ASSESSMENT REPORT

Section 75W Modification Casuarina Town Centre Tweed Coast Road, Casuarina MP 06_0258 MOD 9

Figure 4: Proposed Ground Floor Plan

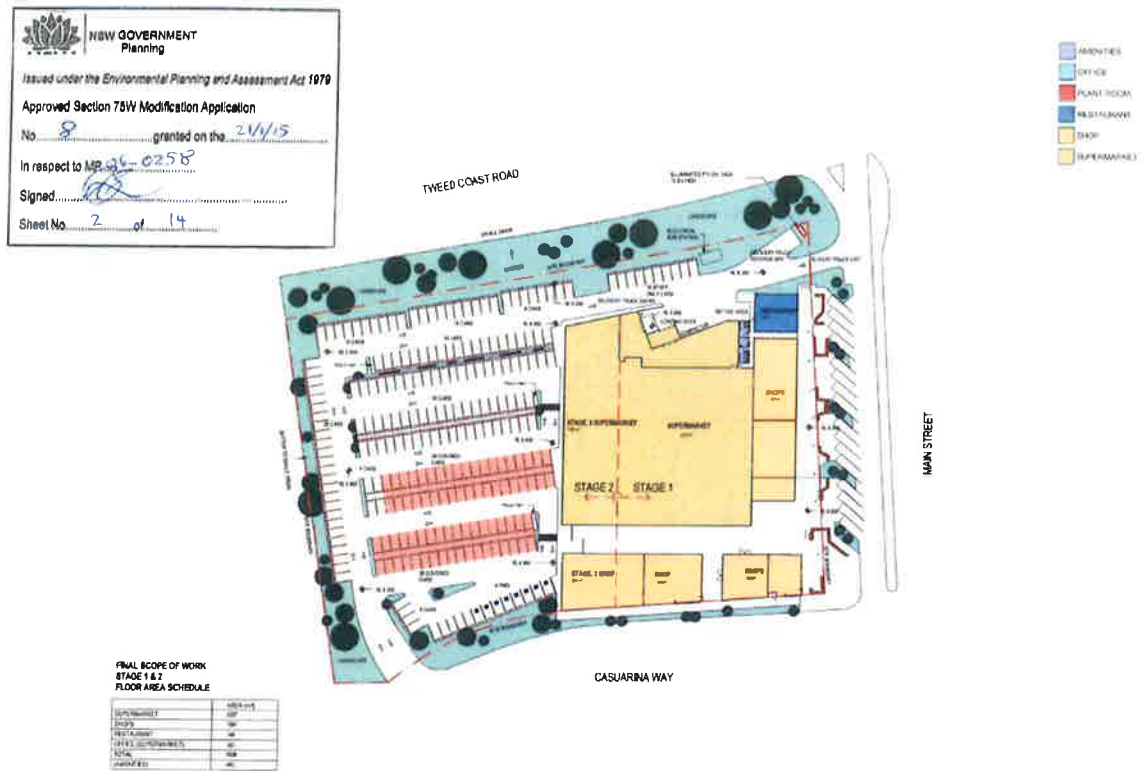
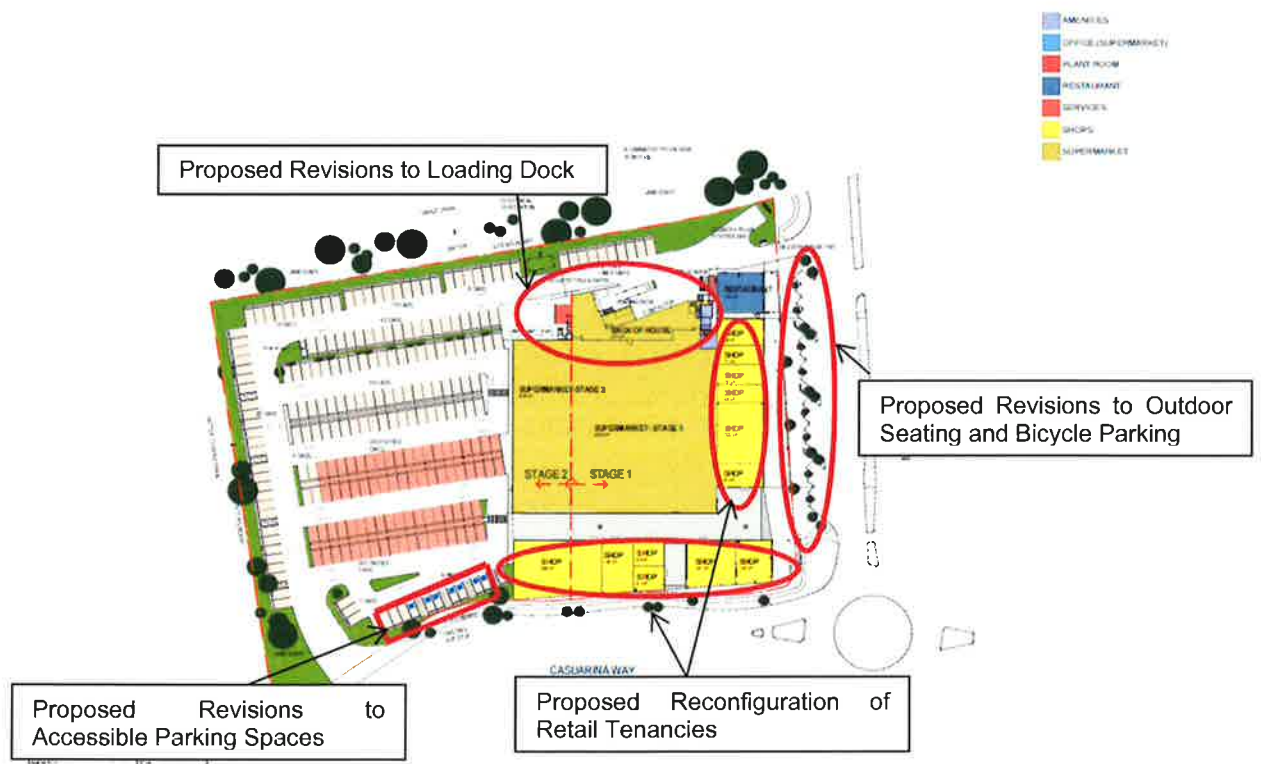
- reconfiguration of the office space and the plant room associated with the supermarket;
- inclusion of a refuse area, fire pump room and sprinkler tanks, and an electrical switchboard adjacent to the loading dock;
- minor design changes to the northern and western elevations to facilitate the installation of a secondary lower roof to the restaurant on the northern and western elevations, the installation of screening and signage on the northern elevation, and design refinements to the breezeway and the removal of the windbreak screens on the western elevation;
- revisions to the materials palette;
- reconfiguration of the specialty shop tenancies;
- refinement of the roof design, including the provision of access to the roof plant area;

- the internal modifications will improve the functionality of the building for the end users and will ensure compliance with the requirements of the BCA;
- the proposed modifications to the building elevations, including the installation of additional signage and modifications to the schedule of materials and finishes will not significantly alter the character of the building in comparison to the approved project; and
- the revisions within the car park and public domain will ensure compliance with the accessible car parking requirements of Australian Standard 2980 and will ensure the provision of suitable outdoor seating and bicycle parking facilities.

Accordingly, the Department has recommended modifications to Condition A1 to include the revised elevations and floor plans within the schedule of approved drawings.

Figure 10: Maximum Proposed Building Height (Western Elevation)

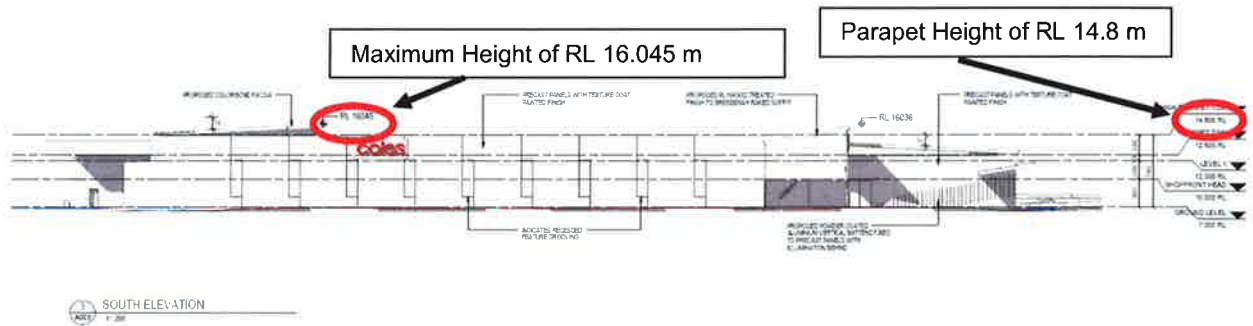
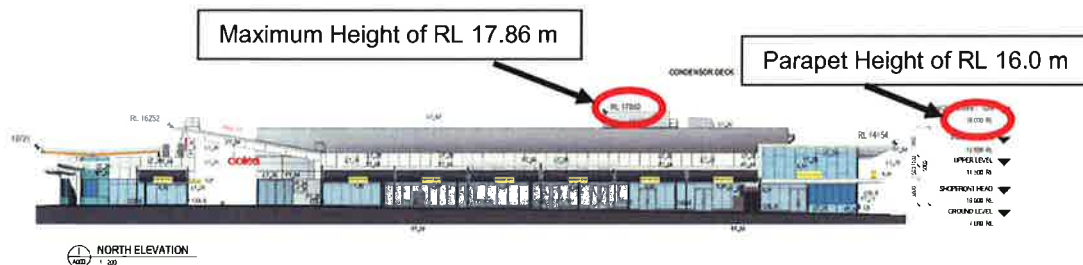
The application seeks approval to increase the maximum height of the building by 1.8 m from RL 16.045 m (approved breezeway feature roof) to RL 17.86 m (top of the proposed condenser deck). In addition, the application also seeks approval to increase the height of the building parapets by 1.2 m from of RL 14.8 m to RL 16.0 m.

The Department has reviewed the proposed changes to the building height and has concluded that due to the mechanical plant being centrally located within the roof plane and setback from the building parapets, the mechanical plant would only be visible from distant vantage points where views to the site are screened by existing street trees or other structures (see **Figures 12 and 13**).

In addition, the Department has concluded that the additional building height will not result in a perceivable increase to the bulk and scale of the building in comparison to the approved project. Given the above, the Department supports the proposed increase to the height of the retail centre.

Figure 11: Factors Driving the Proposed Increase to the Height of the Retail Centre

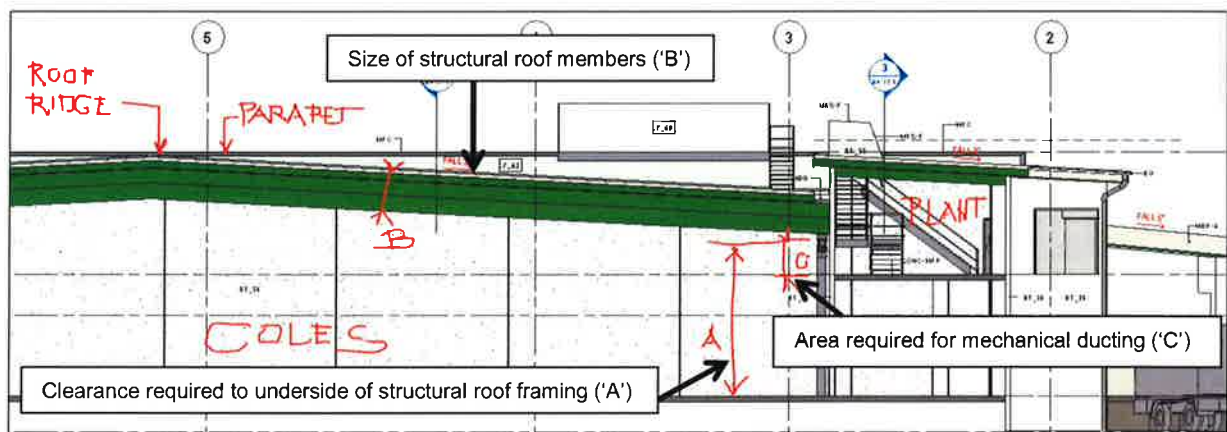
The Proponent has advised that the proposed modifications to the height of the building are required to ensure that there is sufficient clearance between the underside of the roof and the structural framing to accommodate the installation of the structural members and mechanical ducting (see **Figure 11** below). Furthermore, the Proponent has advised that it is seeking to increase the height of the building parapets to mitigate the visual impacts associated with increasing the height of the condenser deck.

Figure 14: Design Specifications for the Approved Illuminated Pylon Sign

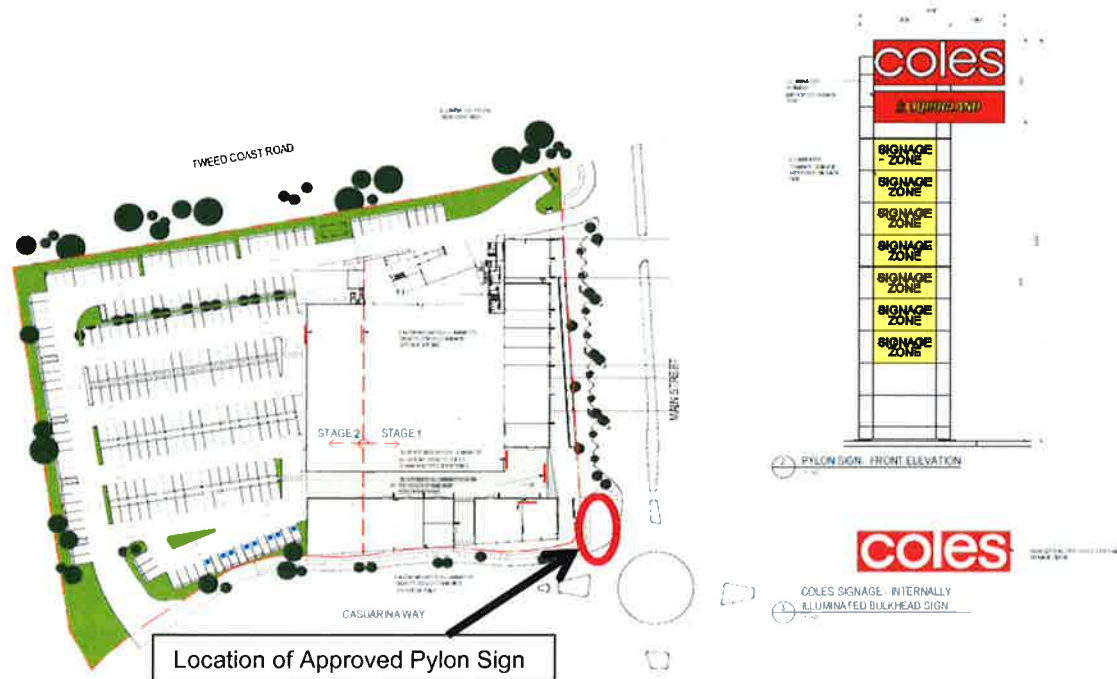
The Department notes that the RMS raised safety concerns with the design of the pylon signage and requested the following design changes to address these issues:

- the name of the centre should be included on the sign;
- no more than five lines of information should be displayed on the sign;
- all signage should be of a sufficient size for drivers to comprehend from the Tweed Coast Road; and
- all illumination must meet the relevant design standards.

The Department has reviewed the RMS' comments and agrees that the Proponent has not demonstrated that the signage proposed to be installed on the pylon sign will not cause any adverse road safety issues. Accordingly, the Department has recommended modifications to Condition B5B to ensure that the final design of the pylon signage addresses the issues raised by the RMS. The recommended wording for Condition B5B is as follows:

"B5B Illuminated Pylon Sign

Prior to the issue of a Construction Certificate for the installation of the 12 m high illuminated pylon sign, the following information must be submitted to and approved by the Secretary:

- (a) drawings of the pylon sign containing the following:*
 - *the name of the centre; and*
 - *no more than five lines of signage information;*
- (b) details demonstrating that design of the sign complies with the requirements of Australian Standard 1906.1:2007;*
- (c) evidence of consultation with the Roads and Maritime Services that the final design of the sign complies with (a) and (b) above;*
- (d) an assessment of the sign against the requirements of State Environmental Planning Policy No. 64 Advertising and Signage and State Environmental Planning Policy (Infrastructure SEPP); and*
- (e) details demonstrating compliance with the Australian Standard for the Control of Obtrusive Effects of Outdoor Lighting (AS 4282-1997)".*
